UNITED STATES  
NUCLEAR REGULATORY COMMISSION  
WASHINGTON, D. C. 20555

Docket No. 50-201

Mr. Ralph W. Deuster, President  
Nuclear Fuel Services, Inc.  
6000 Executive Boulevard, Suite 600  
Rockville, Maryland 20852

Reference: NRC Letter to NFS dated June 27, 1978

8D-2 PUMPOUT TIME ESTIMATION

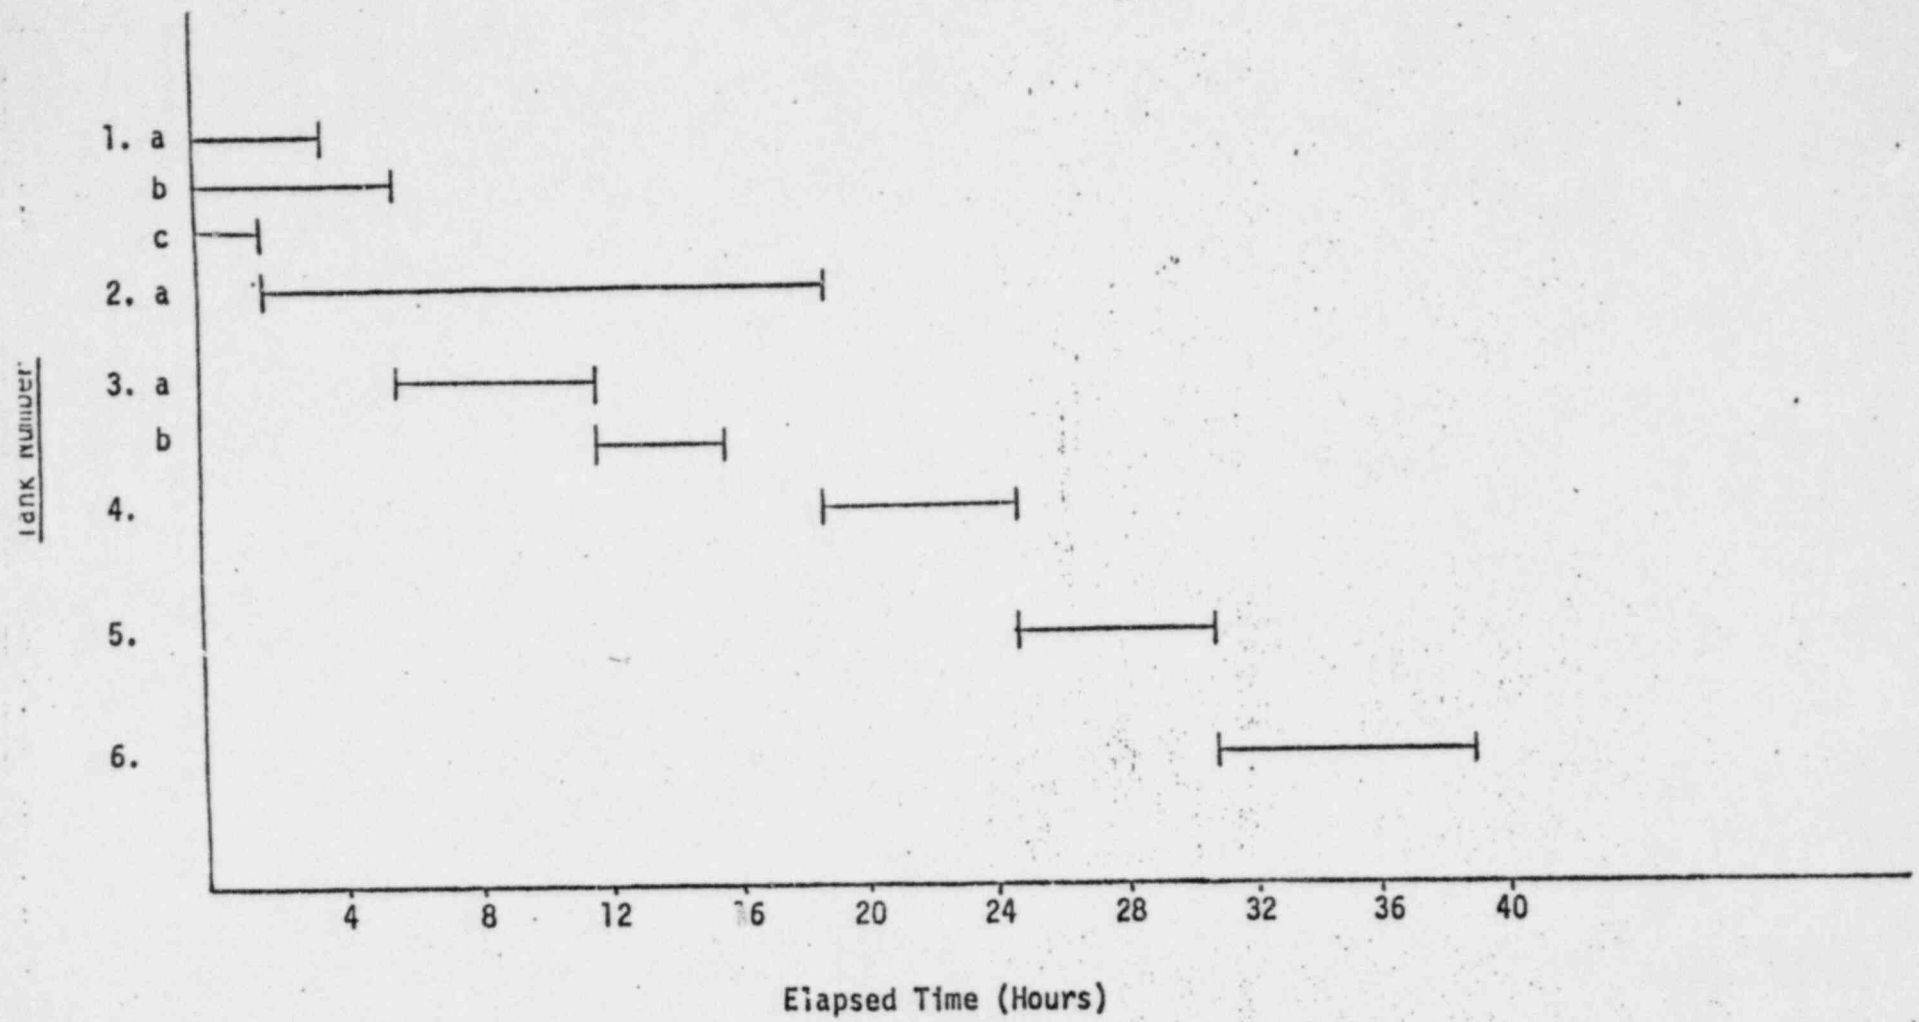
1. Evaluate the overall time required to conduct waste transfer in the event a leak develops in 8D2. The overall time should begin with the initiation of leakage and conclude with the completion of waste transfer and any subsequent transfer line flushes and transfer equipment removal. This evaluation of the time required for waste transfer should include, but not necessarily be limited to:
  - a. Estimates of leak rates; including assumptions used.
  - b. Time required to detect the leak.
  - c. Reliability of waste tank pan high level alarms and the tank farm trouble alarms.
  - d. Reliability of the pan pumpout pumps.

- e. Time to pump down condensate from spare tank 8D1.
  - f. Time to perform each step in the 8D2 pumpout procedure.
2. Verify the operational capability of the 8G2 special transfer pump and motor. This verification should be conducted on a periodic basis and should include but not necessarily be limited to:

Please provide us with the revised 8D2 pumpout procedure and the evaluations requested above within two months of the date of this letter. We would be happy to discuss these items with you at any time.

Attached is our time and motion summary of the procedure which starts with 8G-2 in the 8D-1 tank.

<u>Job</u>	<u>Man-Hrs</u>	<u>Elapsed Time</u>	<u>Sub-Total Time Per Job</u>	<u>Total Elapsed Time</u>
1. a. Assemble crane and move to WTF:				
Crane operator      4 hrs				
Oiler                    4 hrs	8	4		
b. Prepare 8D-1 area, make plastic bags, etc.:				
2 Operators          4 hrs	12	6		
c. Connect 8D-1 pumpout line				
2 Mechanics          2 hrs	4	2	2	2
2. a. Pumpout 8D-1 to Lagoon 1. Use 8G-2 @ 100 gpm. Assume 100,000 gal in 8D-1				
		17	17	19
3. a. Prepare 8D-2 area for plug pulling and pump installation.				
2 Operators          6 hrs				
1 H&S                    6 hrs	18	6	(6)	
b. Remove port plug from 8D-2.				
Crane Operator      4 hrs				
Oiler                    4 hrs				
2 Mechanics          4 hrs				
1 H&S                    2 hrs	18	4	(10)

<u>Job</u>	<u>Man-Hrs</u>	<u>Elapsed Time</u>	<u>Sub-Total Time Per Job</u>	<u>Total Elapsed Time</u>
4.	a. Remove 8G-2 pump from 8D-1 and install in 8D-2				
	Crane Operator	6 hrs			
	Oiler	6 hrs			
	2 Operators	6 hrs			
	H&S	<u>6 hrs</u>			
		24	6	6	25
5.	a. Connect discharge line from 8G-2 to 8D-1.				
	Crane Operator	1 hr			
	2 Mechanics	6 hrs			
	Oiler	<u>1 hr</u>			
		8	6	6	31
6.	a. Run water line to sparge ring on pump.				
	2 Mechanics	3 hrs			
		6	3		
	b. Cover line from 8D-2 to 8D-1 with 3' of dirt.				
	Bulldozer Op.	4 hrs			
	Oiler	<u>4 hrs</u>			
		8	4		
	c. Shield around pump with lead and steel.				
	2 Operators	4 hrs			
		8	4		
	d. Wire pump.				
	2 Electricians	8 hrs			
		<u>16</u>	8	8	<u>39</u>
	TOTALS				
		<u>130</u> M-H			<u>39</u> Hrs

### BASIS FOR THREE FEET OF EARTH SHIELDING OVER TRANSFER LINE

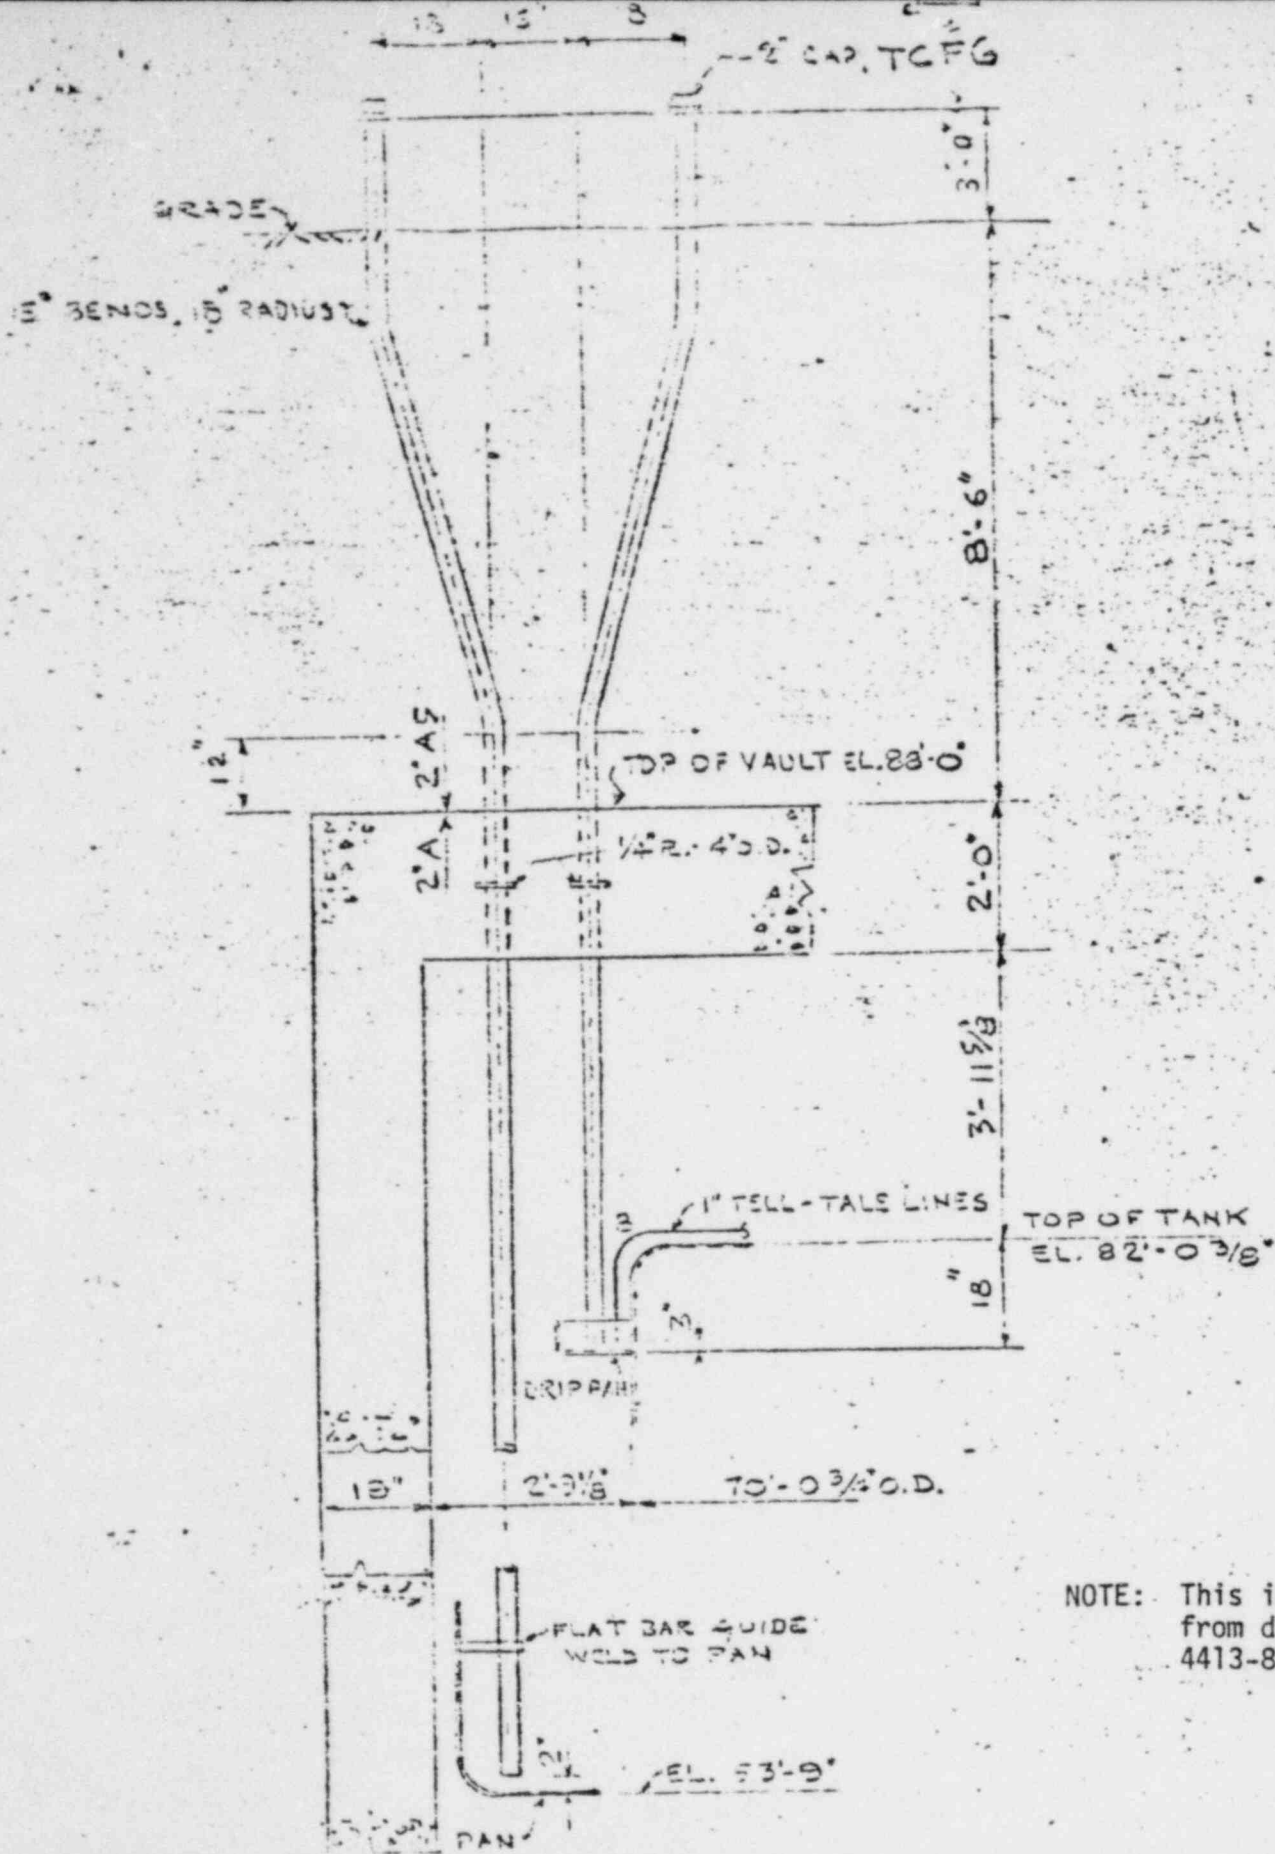
- a. A calculation of personnel exposure received during transfer equipment installation and waste transfer.
    - b. A calculation of the effectiveness of the three feet thick dirt shield around the transfer line and the lead and concrete shield around the 8D1 and 8D2 pumpout and sample hatches.

The procedure calls for three feet of soil or equivalent shielding over the pipe during the transfer. Calculations (attached) show that this would reduce the radiation dose rate to less than 1 mr/hr at the surface of the dirt.

The 8D-2 solution has Cesium-137 and -134 isotopes as the principal gamma emitters. A concentration of 5.5 mCi/ml Cs-137 was used.

The model for calculation was the series of point sources. The unshielded dose rate at one meter was 22 Roentgens per hour.

The mass attenuation coefficients listed in the Radiological Health Handbook were used to determine half value layers and with the application of an estimated dose buildup factor, a shielded dose rate was determined to be 0.6 milliroentgens per hour.

The mathematical calculations were compared with standard shielding graphs from the Rad Health Handbook which generally confirmed attenuations of ten thousand fold by about 40 inches of earth.
